## RESPONSE TO REQUEST FOR ADDITIONAL INFORMATION

### APR1400 Design Certification

Docket No. 52-046

RAI No.: 479-8605  
SRP Section: 09.02.01 - Station Service Water System  
Application Section: 9.2.1  
Date of RAI Issue: 05/10/2016

Figure 9.2.1-1 Essential Service Water System Flow Diagram

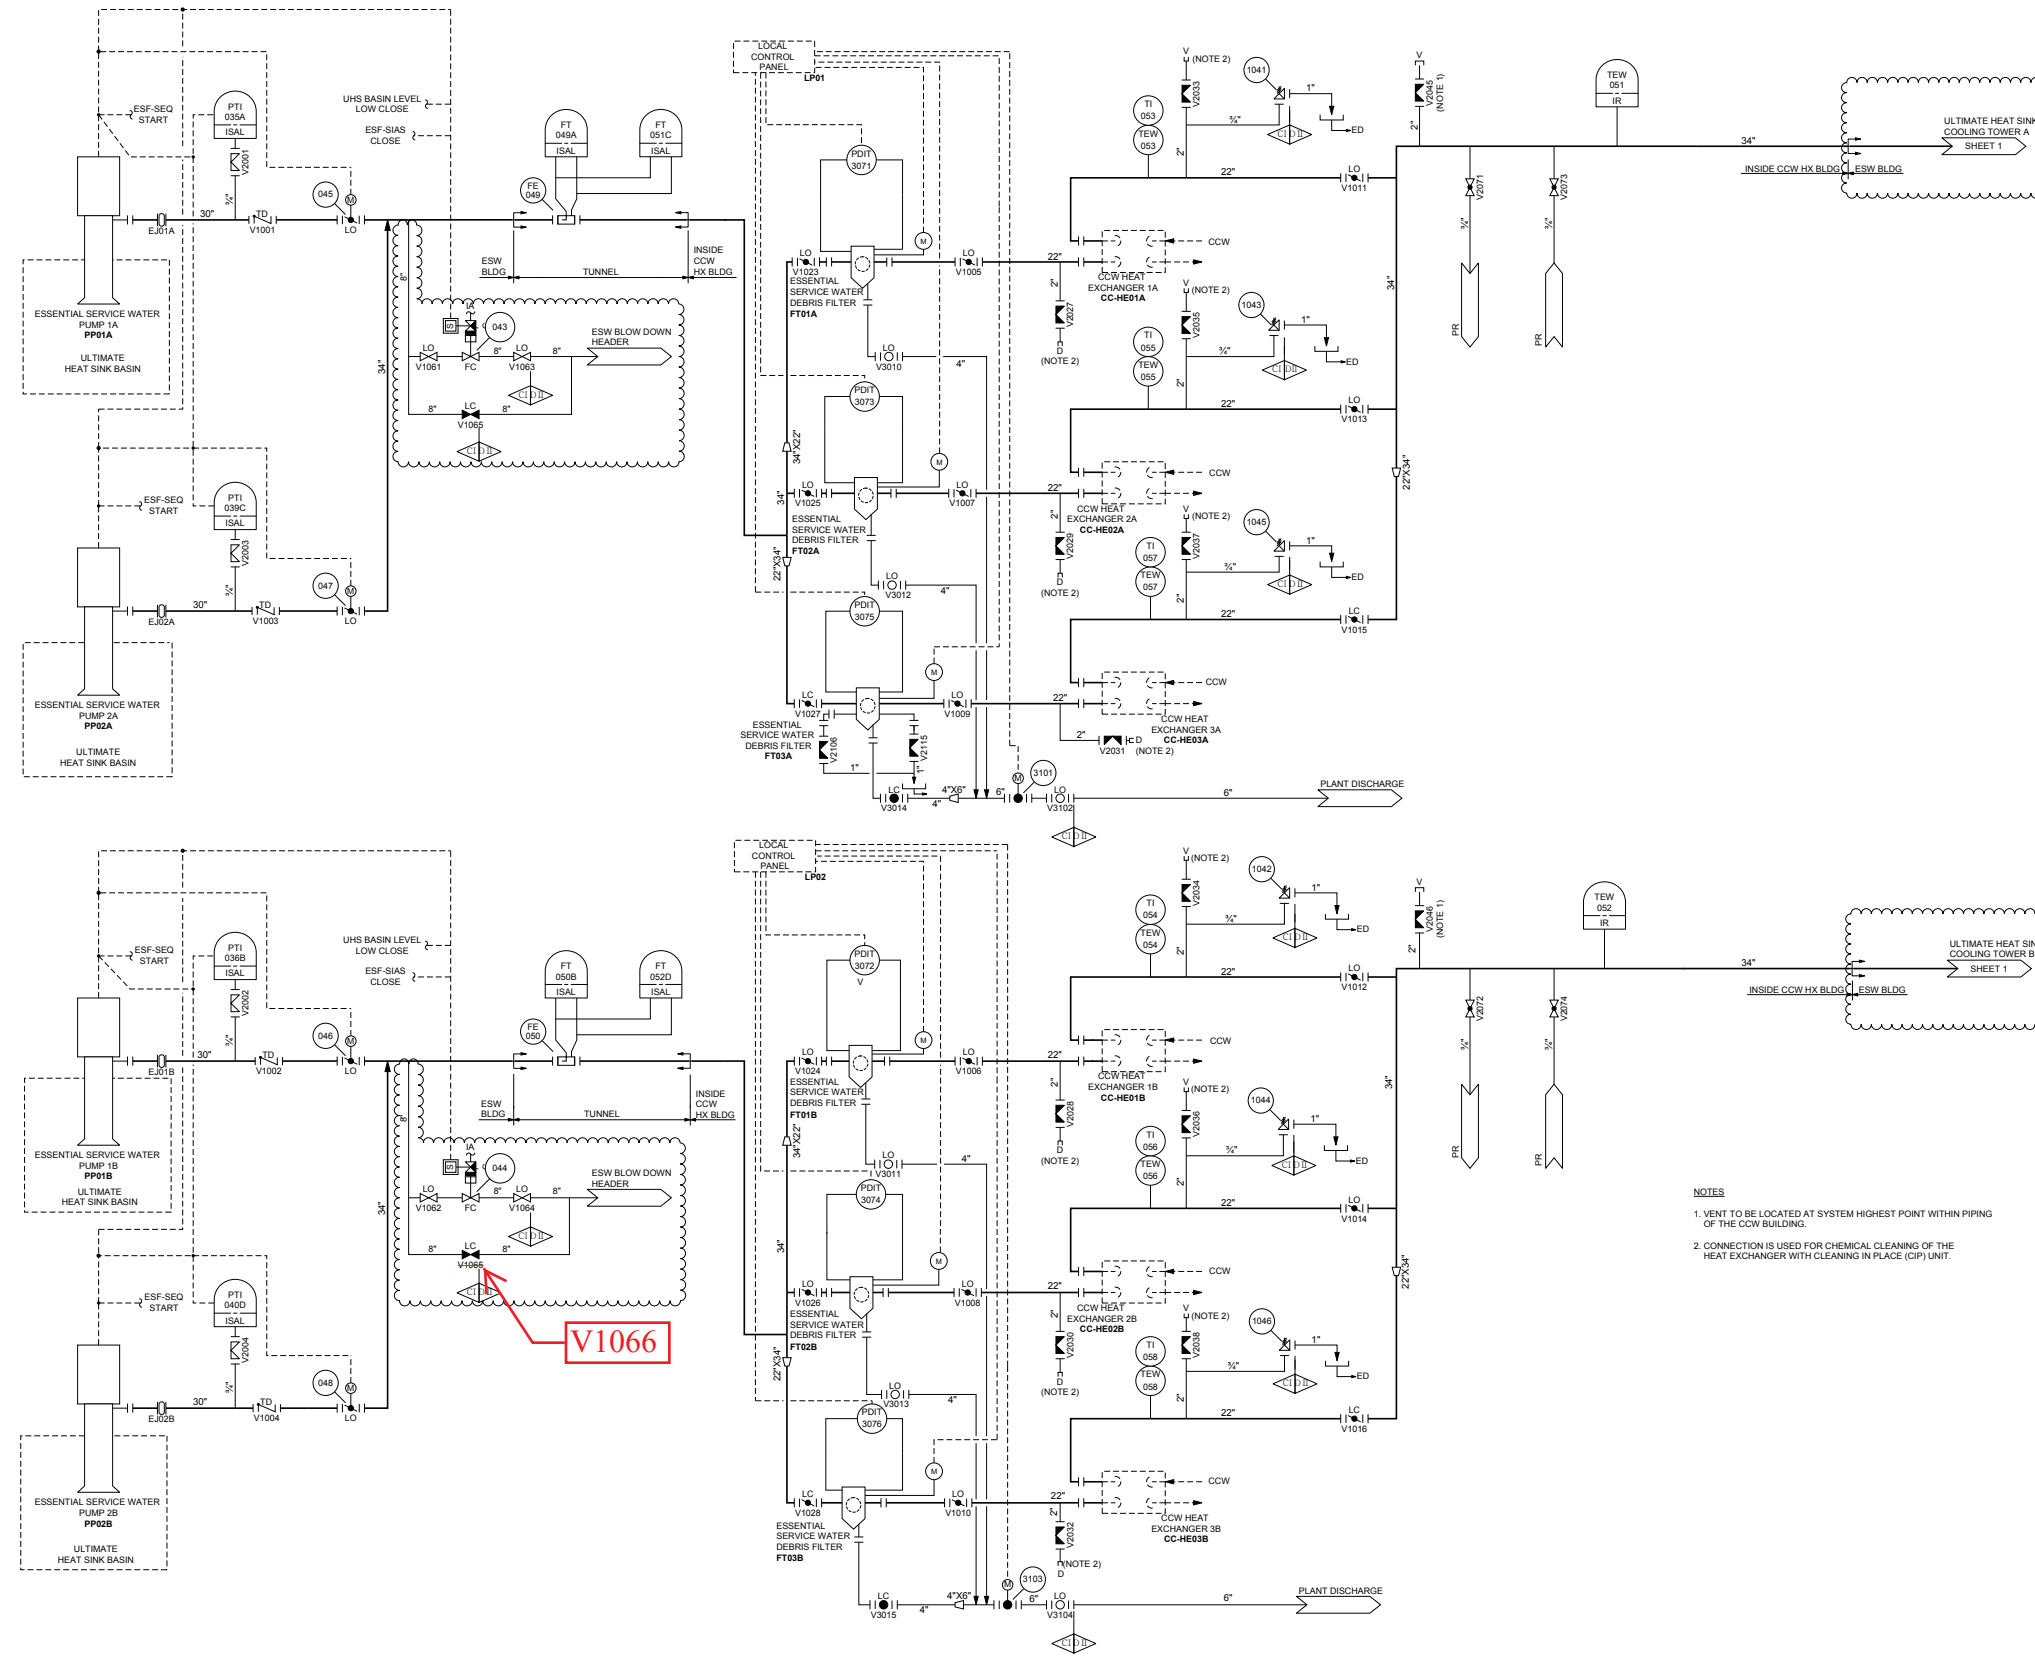
In RAI 211-8236, Question 09.02.01-4, the staff requested the applicant to clarify whether the boundary isolation valves separating the nonsafety- from the safety-related portions of the ESWS are included for inservice testing and inspection.

The first part of the response that “the boundary isolation valves are not included for in-service testing and inspection” is inconsistent with the second part of the response that “they are used only for system or component maintenance, in accordance with ASME ISTC code requirements.”

The staff’s understanding from the response and other design certification applications is that the boundary isolation valves are tested in accordance with ASME OM Code Subsection ISTC, “Inservice Testing of Valves in Light-Water Reactor Nuclear Power Plant.” The applicant is requested to confirm and revise the response, and incorporate it into the DCD.

V1065 of Figure 9.2.1-1 in DCD Tier 2 will be corrected to V1066 as indicated in the attachment.

In DCD Tier 2, Figure 9.2.1-1 will be corrected as indicated in the attachment.
